From: Jonathan Trope
Sent: 28/10/2022 4:43:05 PM
To: Council Northernbeaches Mailbox
Subject: Objection to DA2022/1528 - 92 Lauderdale Avenue, Fairlight
Attachments: 22001 Ltr to Council 28October2022.pdf;

Re: APPLICATION NO. DA2022/1528 – 92 Lauderdale Avenue, Fairlight

This letter sets out their objection to a development application (**DA**) which proposes the demolition of the existing two storey dwelling house and construction of a new three storey dwelling with swimming pool at 92 Lauderdale Avenue, Fairlight (the **development site**).

Figure 2 – Extract of the Lower Ground Floor Plan (Drawing DA-102 by Archer Office), showing the existing building footprint, proposed front building setback and the established building line of the adjacent property to the east

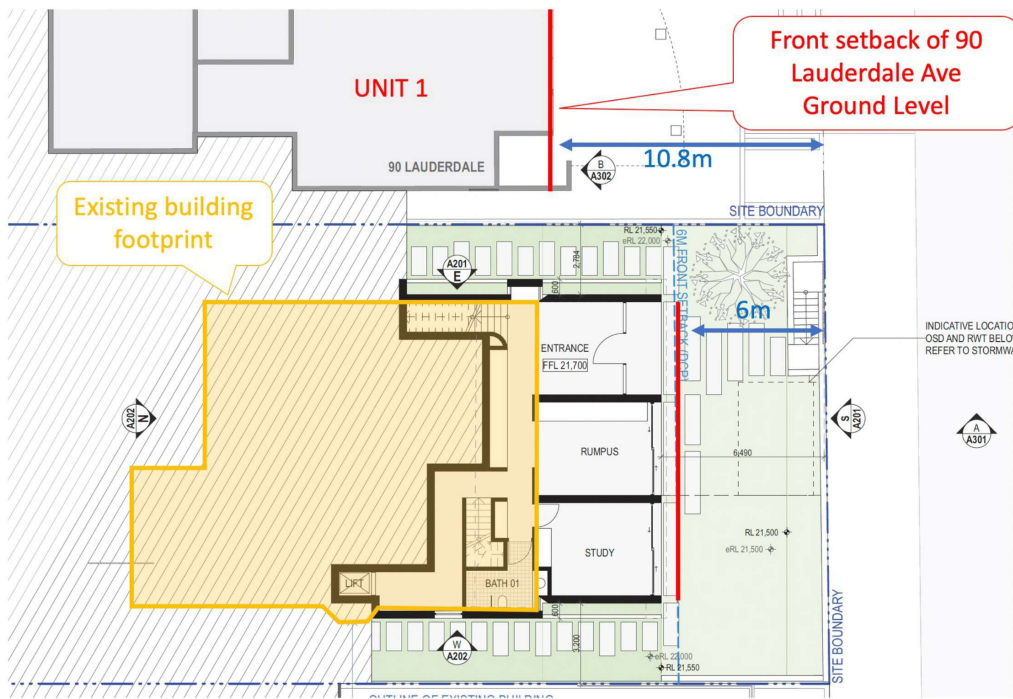
Response: The proposed front setback is inconsistent with immediate established front setback pattern. The proposed front setback is unreasonable using a merit assessment due to the devastating impact it will have on our clients' properties by way of building bulk and solar access.

A 6m standard setback is not appropriate in this context and regard must be given to the adjacent property to the east in establishing the front setback. It is clear that the building has been pushed forward towards the street (Lauderdale Avenue) to minimise the extent of excavation (and cost) to the applicant to the detriment of the adjacent site. Setting the building further back from the front

boundary and in line with the prevailing built form will go a long way in preserving the amenity of our clients' properties.

This is demonstrated at **Figure 2 - 4**, which highlights the existing building footprint, and the current front building line of 90 Lauderdale Avenue at each level in relation to the proposed front setback of the development.
